MONTGOMERY COUNTY HISTORIC PRESERVATION COMMISSION
STAFF REPORT

Address:	20 W. Kirke St., Chevy Chase	Meeting Date:	11/14/2018
Resource:	Contributing Resource Chevy Chase Village Historic District	Report Date:	11/7/2018
Applicant:	Betsy Williams & Tom Moore	Public Notice:	10/31/2018
Review:	HAWP	Tax Credit:	n/a
Case Number:	35/13-18II	Staff:	Dan Bruechert
PROPOSAL:	Window Well Installation and Other Alterations

2 PROPOSED EXT. ELEVATION- EAST SIDE
 SCALE: 3/32" = 1'-0"

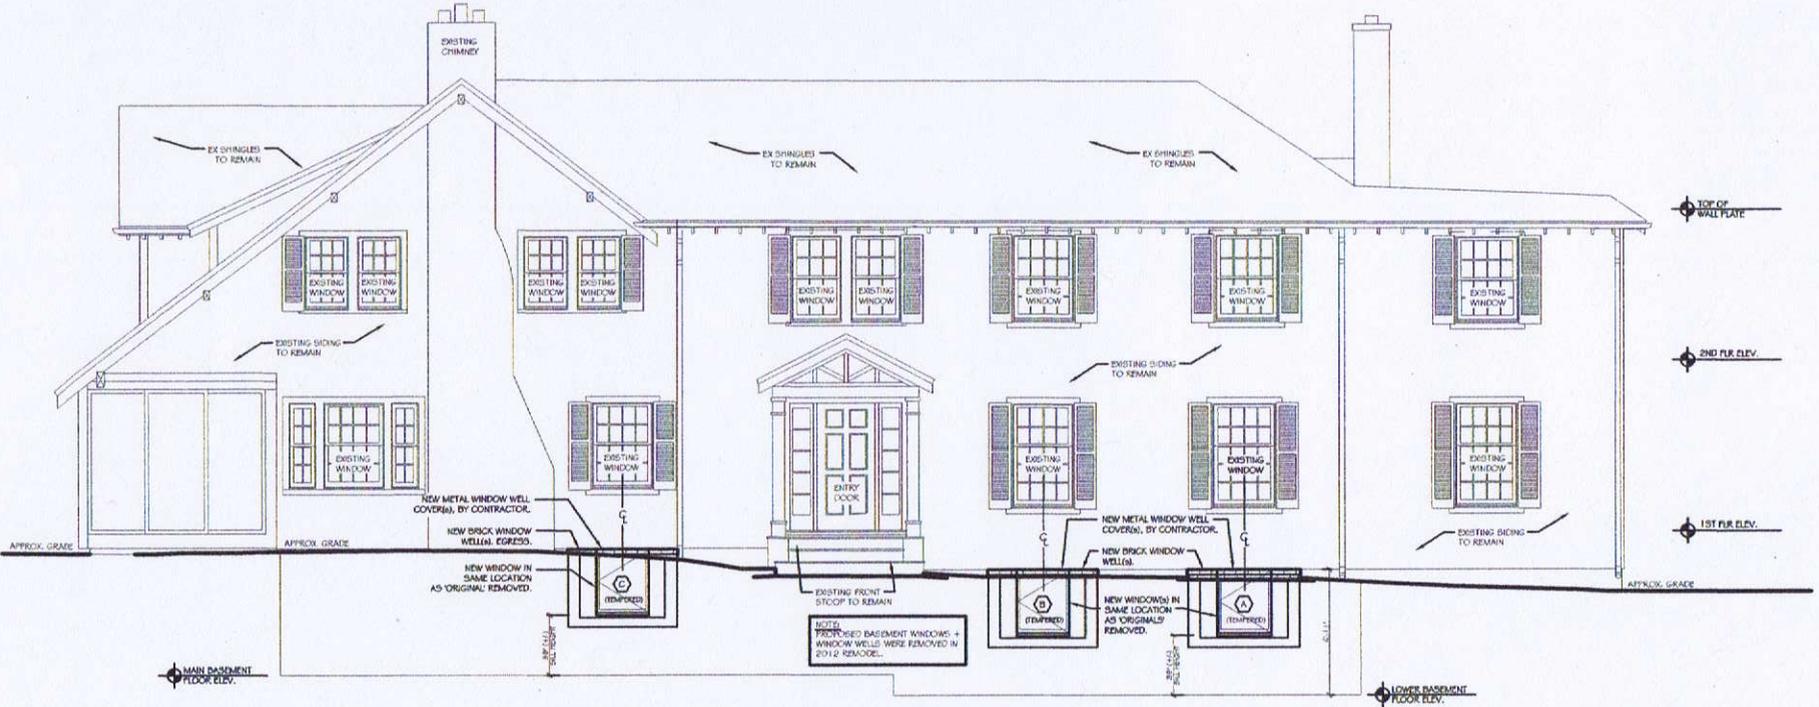
On the east elevation, the applicant proposes to change one opening from a pair of sash windows into a pair of French doors and to introduce two new window openings. All of the work on the east elevation will occur in the 2012 addition and not to the historic house massing. The existing windows are a pair of non-historic six-over-six sash windows. The applicant proposes to install a pair of eighteen-lite wood French doors that will be accessed by a new concrete step. Staff finds the French doors are in keeping with the multi-lite window configuration found through the house and is compatible with the character of the house and surrounding district. The applicant also proposes to install a new four-over-four sash window to the right of the proposed French

doors. This window is to be installed in what appears to be the connector between the historic massing and the 2012 addition. Its introduction will not significantly impact the character of the house or the surrounding district and Staff supports its approval. The last new feature proposed for the east elevation is a skylight proposed for directly over the new window. The skylight appears to match the design and dimensions of the existing skylight on the east elevation. Staff finds that this skylight will not have a dramatic impact on the historic character of the house and supports approval under 24A-8(b)(1).

1 PROPOSED EXT. ELEVATION- FRONT
 SCALE: 3/32" = 1'-0" (NORTH SIDE)

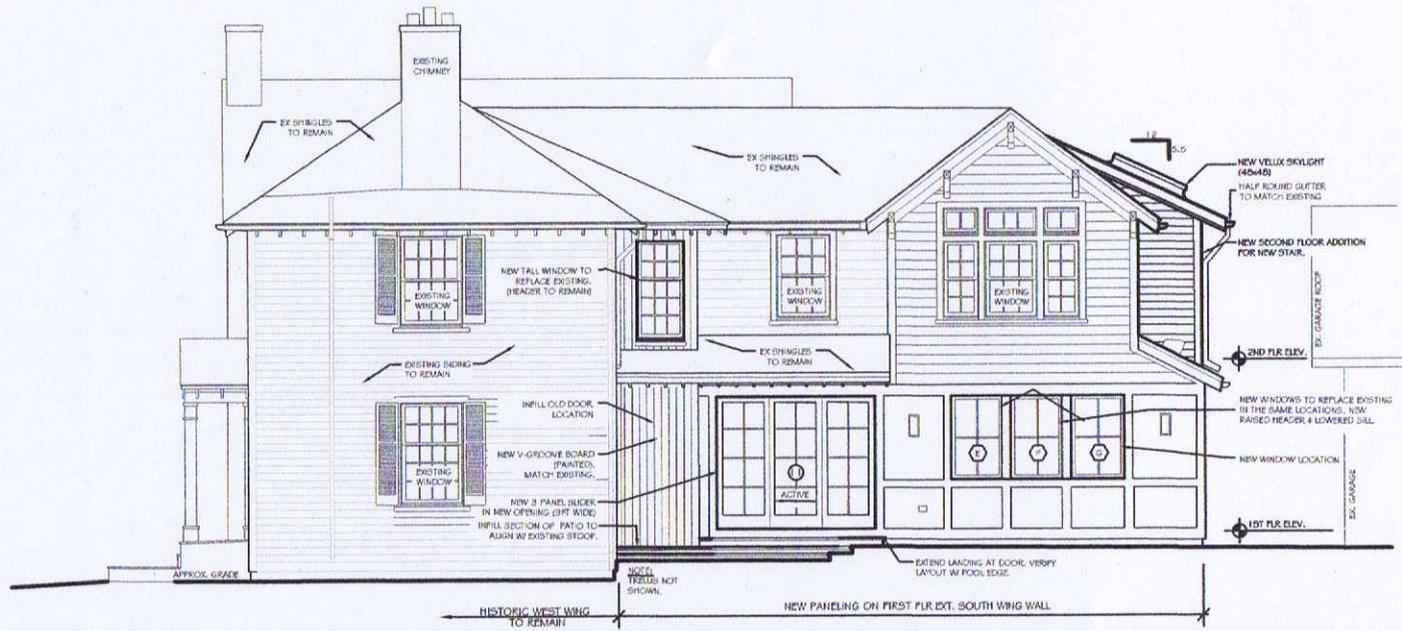
On the front elevation, there were three basement-level windows that were filled in as part of a 2012 remodeling project. The applicant now proposes to install code-compliant egress windows and associated window wells in these openings.

The proposed windows will be single-lite, wood casement windows with brick window wells. The window wells will be covered by a metal grate. The window wells will be constructed so that they project above grade by only a few inches and Staff finds that these will not have a significant visual impact on the historic character of the house or the surrounding district (24A-8(b)(1) & (2)). As these will be placed in the location of the original openings, no historic fabric will be lost from this portion of the project. Staff supports approval of the window wells.

2 PROPOSED EXT. ELEVATION- WEST SIDE
 (A100) SCALE: 3/32" = 1'-0"

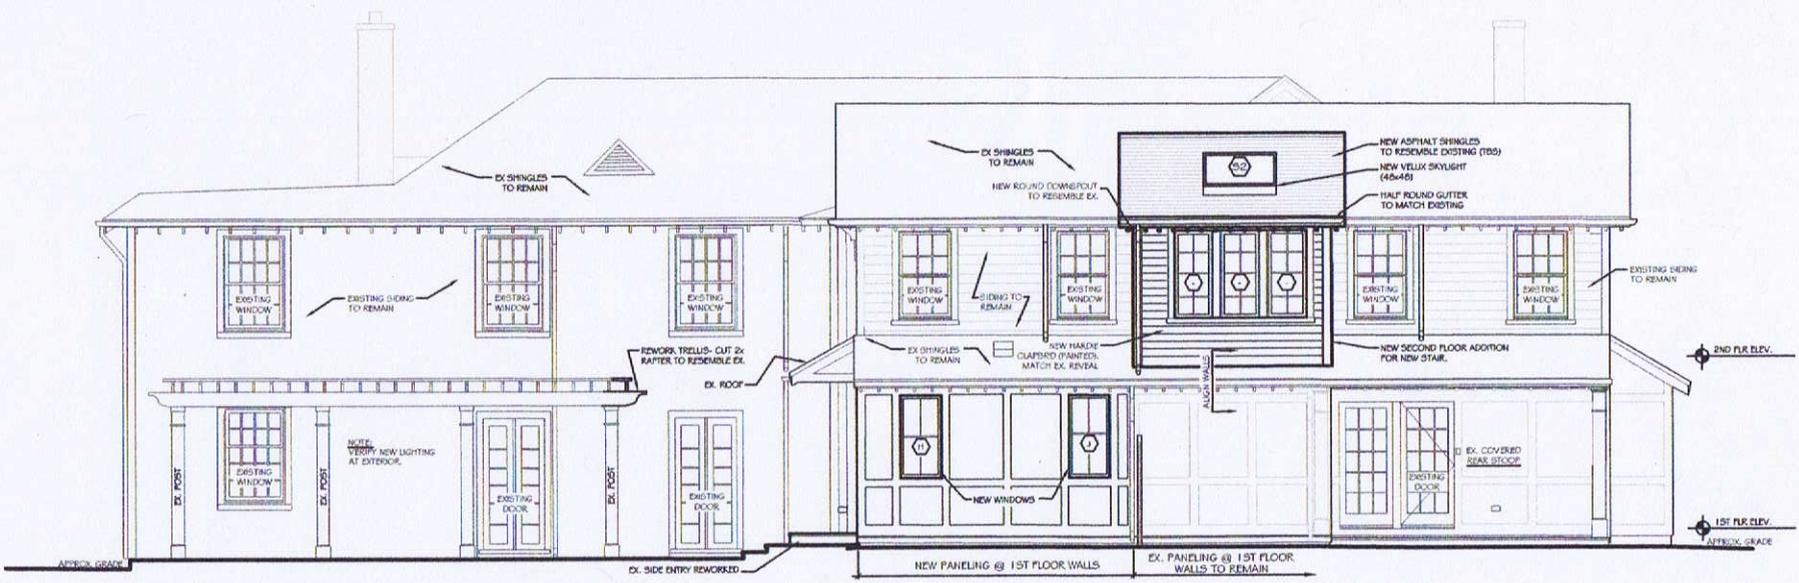
On the west elevation, the applicant proposes changes in three areas: enlarging a sash window, removing two non-historic windows and installing three new windows in their location, and removing a non-historic pair of French doors and installing a three-panel slider door in their place while covering an existing door opening. All of this work is not visible from the public right-of-way and is subject to lenient scrutiny under the *Guidelines*.

In to 2012 addition, the applicant proposes to remove two twelve-lite fixed windows and to install three new four-lite windows in their place. The applicant also proposes to install new paneling on this elevation to create equal spacing – changing from a six-panel configuration, to a five-panel configuration to maintain symmetry. These windows are on a non-historic addition to the house, which face the interior of the yard and will not be visible from the public right-of-way. Staff finds that this proposal will not impact the historic character or the historic fabric of the house and supports approval of this element under 24A-8(b)(1).

On the first floor the applicant proposes removing a pair of French doors with a single door to the left. In its place, the applicant proposes to install a three-panel slider door with each door dividing into eight-lites. The door opening to the left will be filled in with V-groove wood board painted to match the existing siding above. On the second floor, above the existing single door, the applicant proposes to remove an existing six-over-six window and install a taller six-over-nine window in its place. The changes on this elevation are not significant alterations that will be visible from the public right-of-way and will not impact the historic character of the house. Staff supports approval of these alterations under 24A-8(b)(1).
